FW35TT Terminal Tractor Fifth Wheel Product Enhancement Notification

Effective Date: October 1, 2024

FW35TT Top Plate

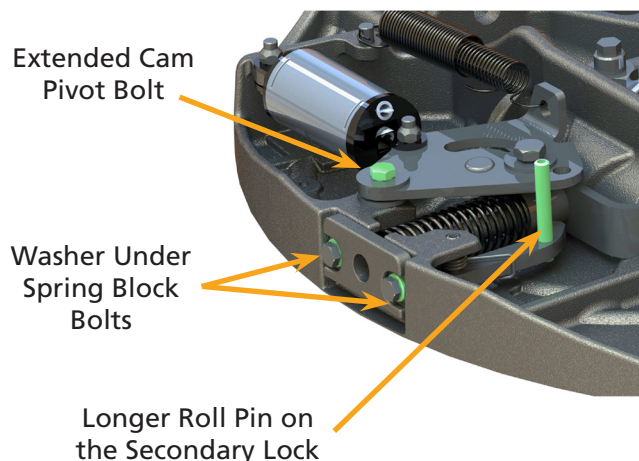
We've refined the design of the FW35TT terminal tractor fifth wheels by incorporating several key component upgrades.

- **Longer Roll Pin on the Secondary Lock:** Enhances security and operational reliability
- **Added Washer Under Spring Block Bolts:** Increases durability and component lifespan
- **Extended Cam Pivot Bolt:** Better engagement and space for future enhancements

Current fifth wheel assemblies, top plates, and rebuild kits will be updated with new components. In addition, a new field kit is available which has only new updated components.
